# Annual Fire Safety Engineer (FSE) Dialogue Session

Friday 17 March 2017

# Fire Engineering Reports

WVR/00052/17 (Original) – Slide #51

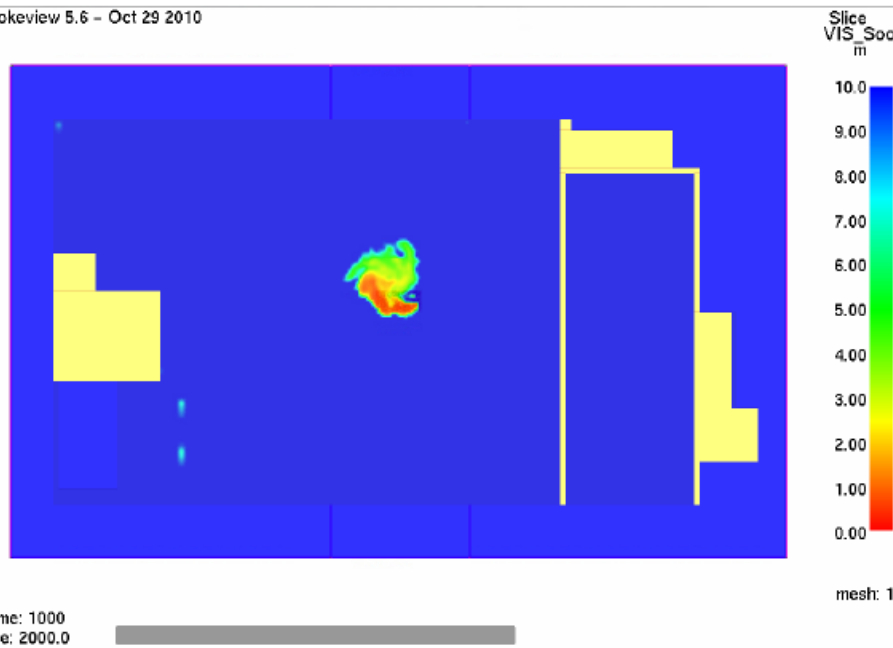
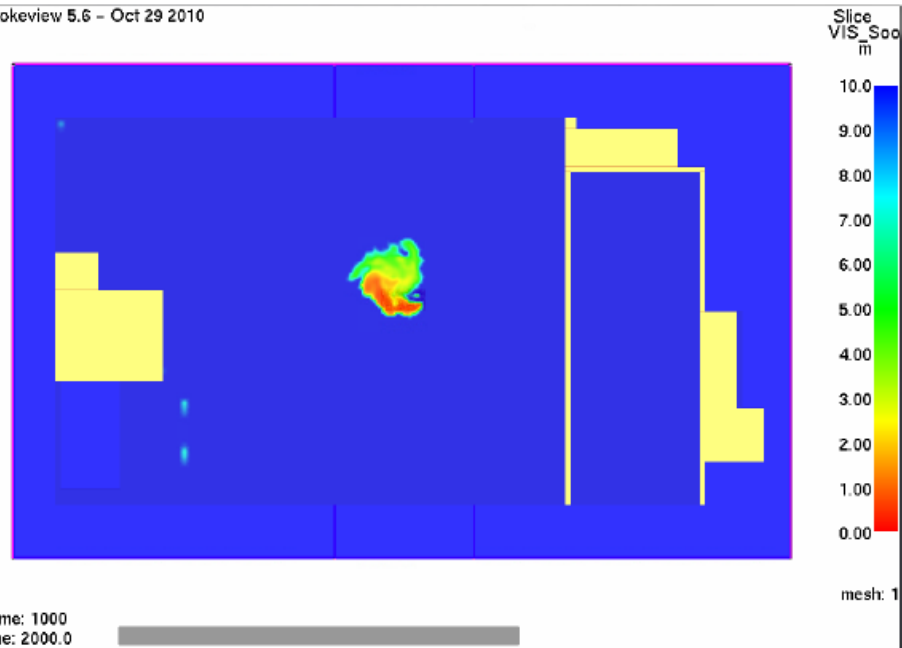
FDS Results – **SS1** (Visibility, Z = 2.5m above FFL @ L3)

FDS Results – **SS2** (Visibility, Z = 2.5m above FFL @ L3)

Reason for error: The error occurred due to a typo on the heading.

# Comparative Study (Visibility Slides) – Tower A

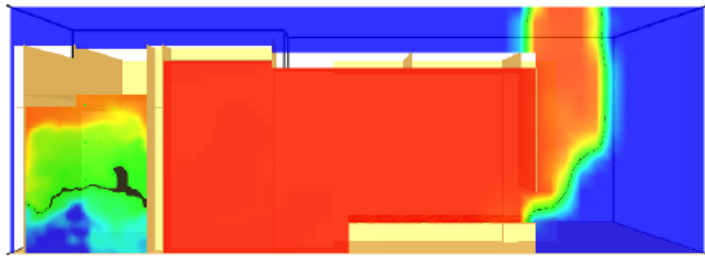
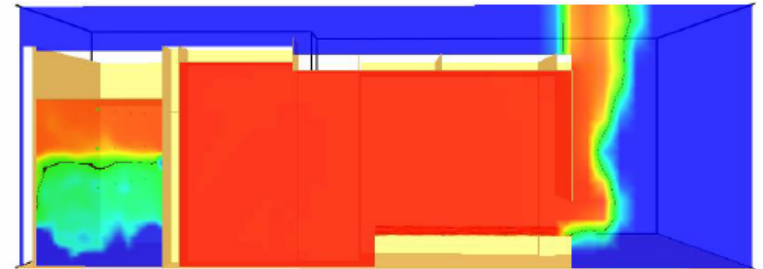
## PB – Visibility Slide @ X=0.75m

## CC – Visibility Slide @ Y=0.75m

Figure 9.5.2.1: Design Fire Scenario S1-1S : Activation of Ceiling Sprinklers

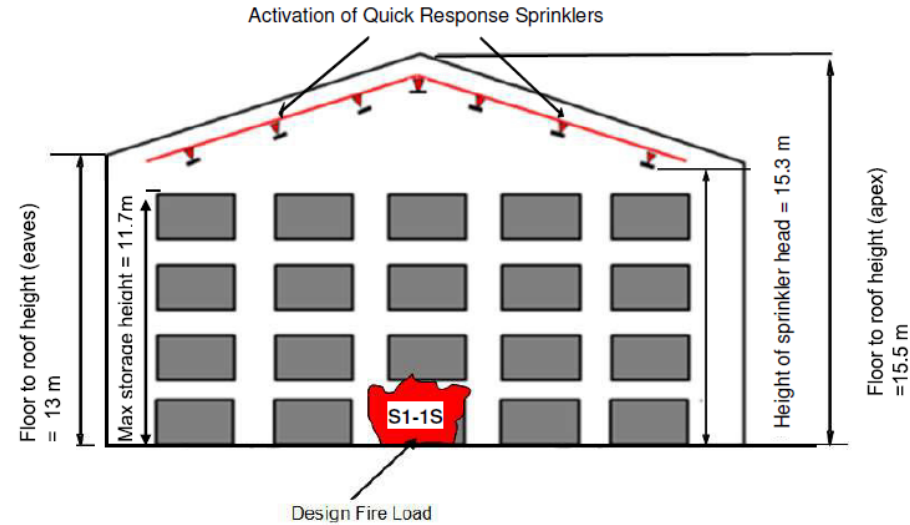
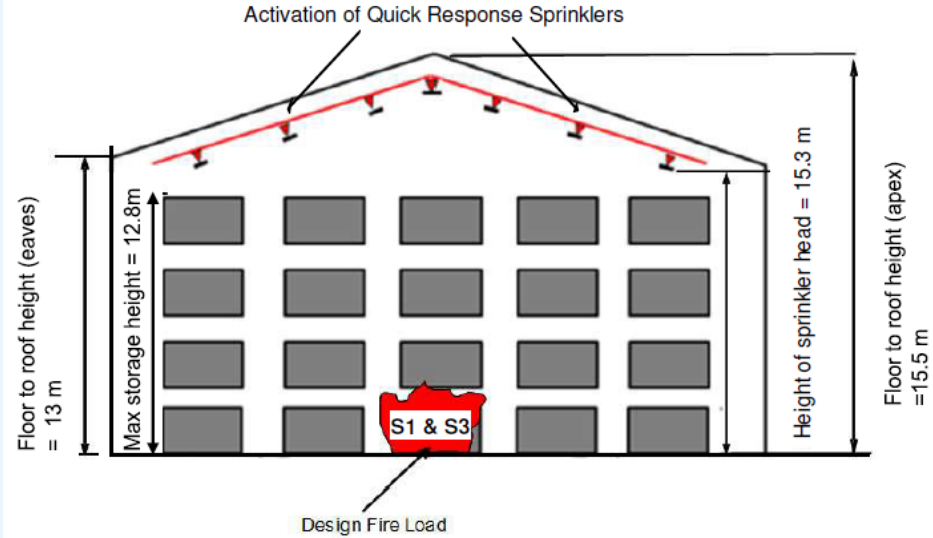
**Storage height = 11.7m or 12.8m ?**

# Visibility – Level B1M

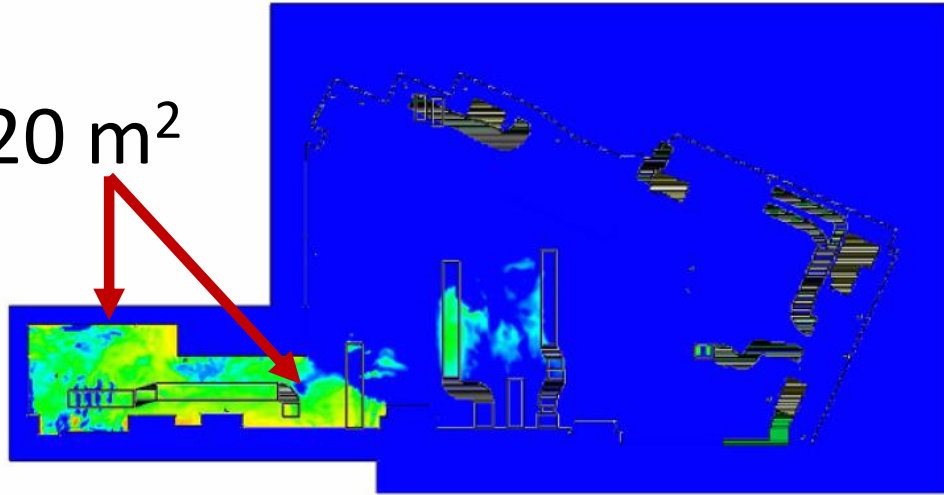
820 m<sup>2</sup>

- “Fail” > 800 m<sup>2</sup>
  - ✓ Discussion:
    - Ceiling beam and duct layout
    - Run more fire scenarios.
